**WALSH BAY ARTS PRECINCT
HERITAGE IMPACT ASSESSMENT**

Client
ARTS NSW

Prepared by:
Design 5 Architects
ABN 22090066194

Date: 23/06/2014
Revision: 4
1: Issue for DRAFT 24/02/2014
2: Issue for FINAL DRAFT 3/04/2014
3: Issue for FINAL 4/06/2014
4: Issue for FINAL 23/06/2014

Figure 7.4.1: FBC design showing the northern edge of the square in line with the northern wall Pier 2/3 breezeway.

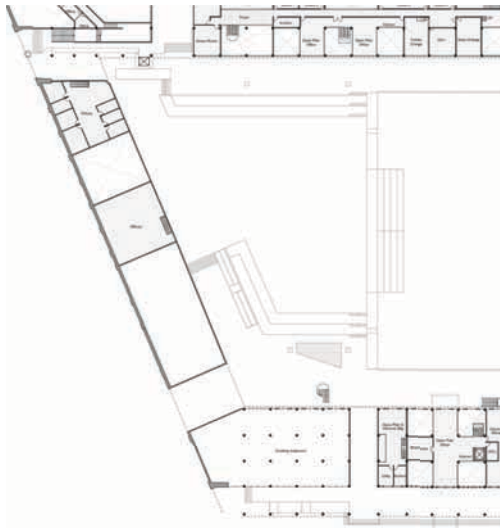
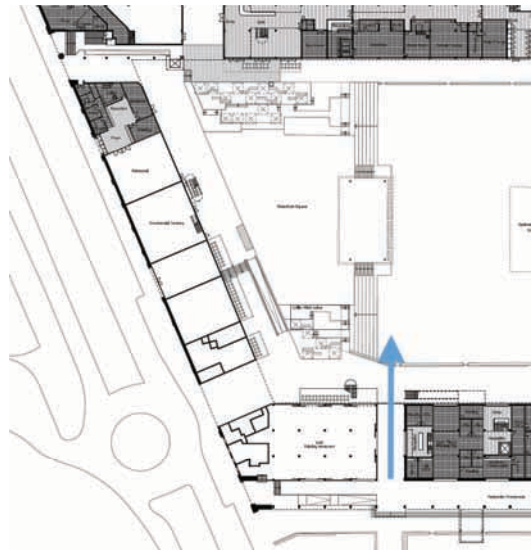
Several options were explored for an area that could be used as covered performance for flexible uses and would be the focal point of the outdoor square. Options included a space that would be located either centrally or off-centre between wharves and toward the north or south end of the square. The most appropriate location from a heritage and architectural context was to centrally locate the performance space and project it into the water. This allowed the rest of the square to be stepped back to give the performance space dominance while also allowing separation from the wharf buildings. The stage aligns with the ground floor breezeway of Pier 2/3 which is a critical sightline and entry to the precinct.

Figure 7.4.2: Current revised design improved to reduce the overall size of the square while emphasising the central performance space as projecting into the water. The blue arrow shows central projection in line with the ground floor breezeway on Pier 2/3.

The design for the cover to the outdoor performance space should be sympathetic and respect the established identity and character of the place. However, within these constraints, there is the opportunity to create a modern structure that reflects current uses and responds to how people interact with historic environments and Sydney Harbour generally as a space for gatherings, events and celebrations. The following principals should be used as guidelines for the design of the shelter to the performance space:

Figure 7.4.1: West side of Pier 2/3, c 1930s. Photo shows former openings on first floor. Potential to reinstate openings on the west side of Pier 2/3 in the location of original openings.

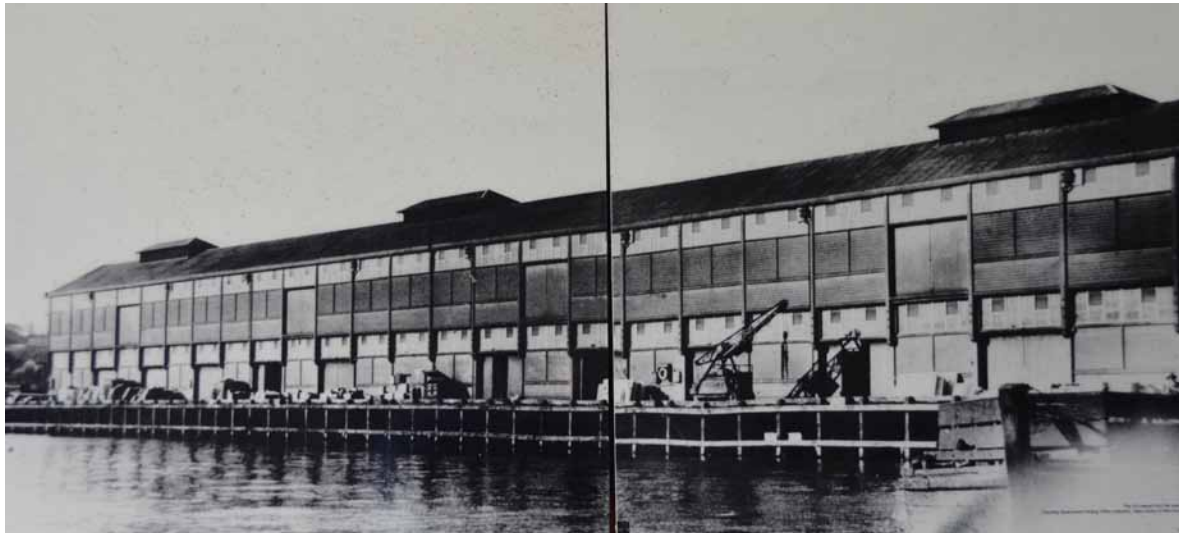
In our research, we have found no documentary or physical evidence to support the suggestion that gantries were ever used on the west side and have therefore not supported their introduction on this side. Evidence suggests that seven gantries were used on the east side (refer to c1975 photographs in Section 8.3.3). The number of loading bay doors on the east elevation of the first floor compared to only four original openings on the west side (at a lower level), would also suggest that gantries were never used on the west side.

Despite lack of evidence for gantries, the underlying intention of the Master Plan was for better activation and address of Pier 2/3 to the west, particularly from the first floor. The proposals for the west elevation are detailed below, together with comments on their heritage impact:

Figure 8.4.4: Existing photo of Pier 2/3 (left) and photomontage (right) showing the likely appearance of raised roof for ACO auditorium and solar array on Pier 2/3. Image taken from the Harbour Bridge, bicycle path

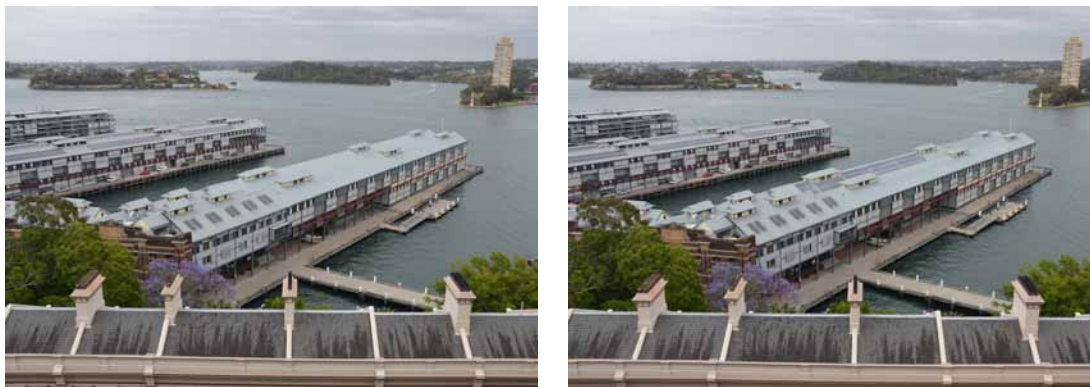
The addition of the solar array on the inside roof slopes have a minor impact and are deemed acceptable. When viewed in context with Wharf 4/5 (refer to photomontage), the additional solar arrays on the internal slopes are consistent with existing arrays on Wharf 4/5. We consider solar arrays to be reversible, have broader environmental benefits and be visually acceptable on these internal slopes only but not on the external slopes.

The relatively recent addition of skylight on the external slopes of south end of Pier 2/3 is an unfortunate impact on this pier and should, if the opportunity arises, be reversed.

Figure 7.6.1: Diagram showing opportunities and constraints for the ground floor.

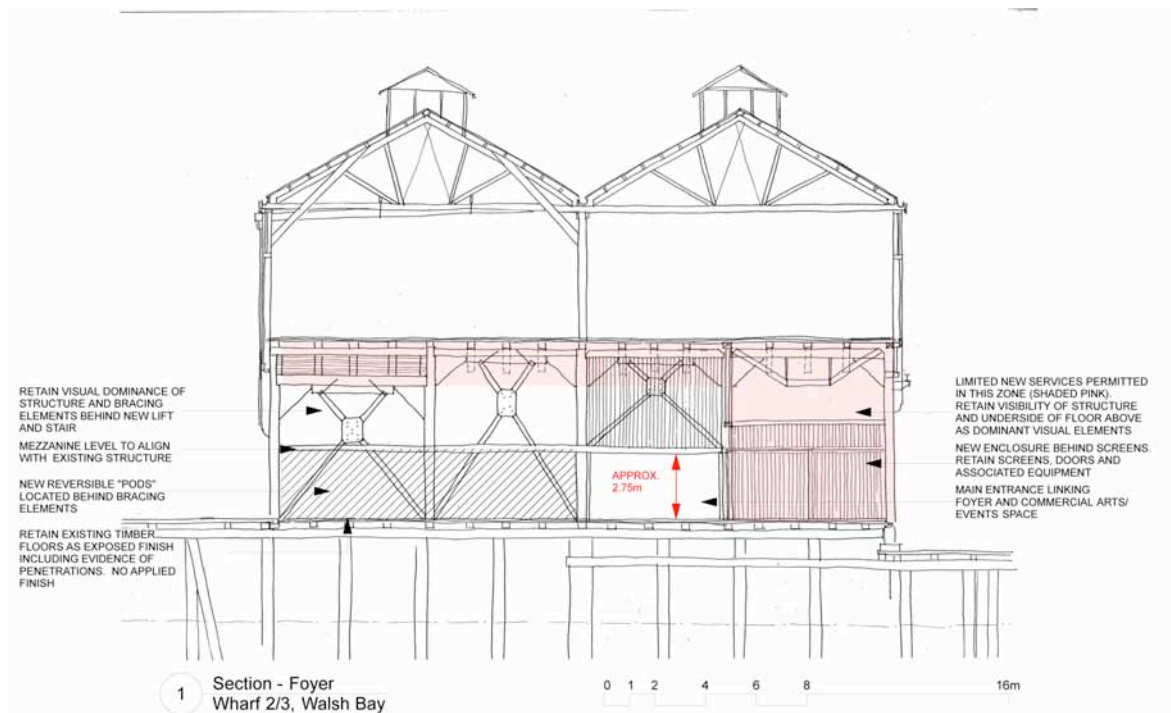
Pier 2/3 Ground floor		
Proposal	Comment	Summary impact
Retain space on ground floor as Commercial Events/Arts Space.	Generally the approach and area allocated for the Commercial Events/Arts space is a positive attribute of the scheme overall. Refer to separate Heritage objectives for Commercial Events/Arts space.	Positive heritage benefit
Kitchen located in Commercial Events/Arts Space.	Refer to separate Heritage objectives for Commercial Events/Arts space for discussion.	Moderate impact if located at the south end of the space.
Shared zone adjacent to Events Arts Space.	Space encroaches on the Commercial Events/Arts space but is acceptable compared to earlier design alternatives which resulted in greater heritage impacts.	Moderate impact however Acceptable
Foyer	The space allocated for the foyer is generous and offers a positive heritage outcome by celebrating and highlighting significant fabric and the spatial qualities of the existing structure. Opportunity to adopt many of the principles used in the Commercial Events/Arts space to strengthen wharf identity in public areas.	Positive

Lift and stair in foyer space	These elements should be built as lightweight minimal structures. The timber bracing on the north side should retain a sense of visual dominance over the space.	Moderate/ Acceptable
Toilets off the foyer space	Doors are located to prevent any impact on the timber bracing. Height of the enclosure should match the height of the existing horizontal timber beam – refer to diagram. Question whether the area allocated for toilets is sufficient and if this is this likely to grow based on population projections for the commercial Events/Arts space.	Low if self contained within existing structure and minimal impact to fabric.

Figure 9.2.1: Diagram showing opportunities and constraints for the Commercial Arts/Events Space.

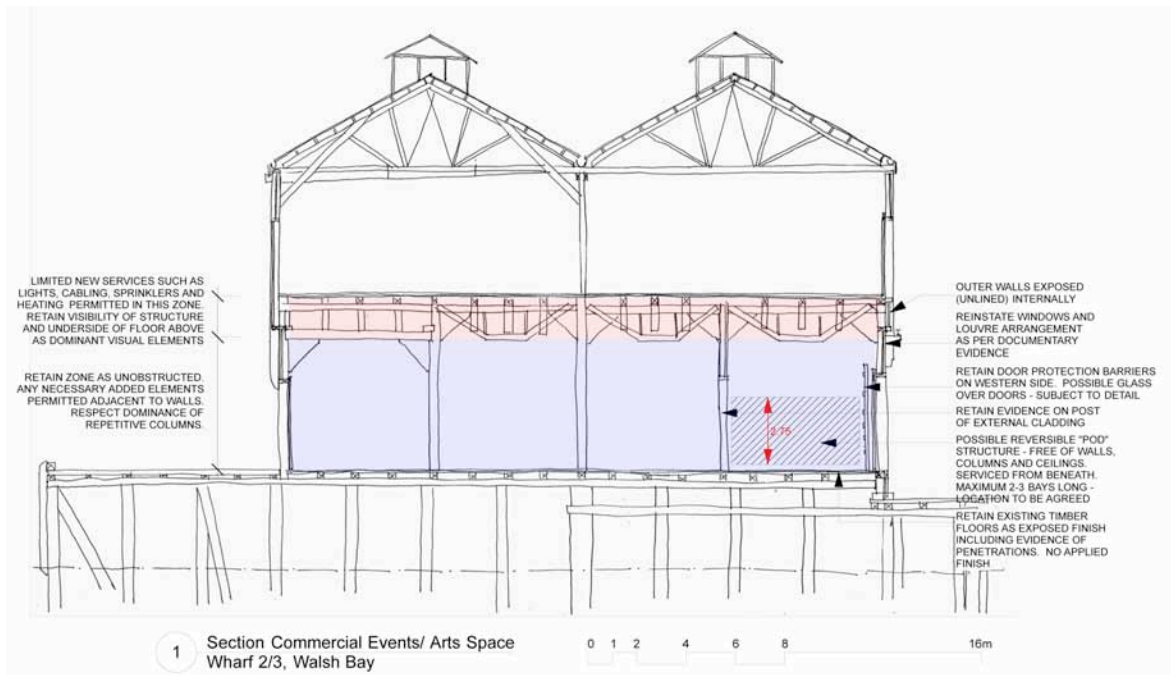
Element	Recommendation
Windows and external walls	<ul style="list-style-type: none"> ▪ Opportunity to remove the later panel of weatherboard on the east side of the north elevation including the adjacent return panel on east elevation to interpret former loggia opening along the east elevation. ▪ Additional external openings are to be avoided. ▪ Inside face of external walls should be left exposed and unpainted. No linings applied unless temporary and reversible. ▪ Window joinery should be painted externally as required. ▪ Opportunity to reinstate the original configuration of windows and louvres based on documentary evidence if required.
Lighting	<ul style="list-style-type: none"> ▪ Retain early steel high-bay lights in their current locations. ▪ Opportunity to enhance the interior with new lighting design that showcases the interior and significant fabric, ceiling, columns, floor, walls etc. ▪ Location of additional lights should be discrete and respect the repetitive and modular configuration of the space. ▪ Any newly introduced light fittings should comfortably sit within the background and not draw attention to themselves. ▪ Indirect lighting is preferable for all additional lighting. ▪ Fluorescent hanging lights are intrusive and should be removed.

Services	<ul style="list-style-type: none"> ▪ Where services are reticulated within the space, they should be face fixed with clamps or screws and be easily removed without damage. Services must not be chased. Glues must not be used. ▪ Radiant heaters and/or fans may be suspended from the ceiling. Their location should respect the regularity of the grid and earlier policies and they should not dominate the space. ▪ Services should not damage significant fabric. Any new service, including a cable or hydraulic run, must be configured to go around existing fabric rather than cut through it or follow existing services routes. ▪ Service reticulation under the floor is encouraged as opposed to within the space. ▪ New power supply points may be provided by lift up panels within the floors, adjacent to columns or walls or other proven non-intrusive methods. Where possible, they should be fitted in the location of previous repairs.
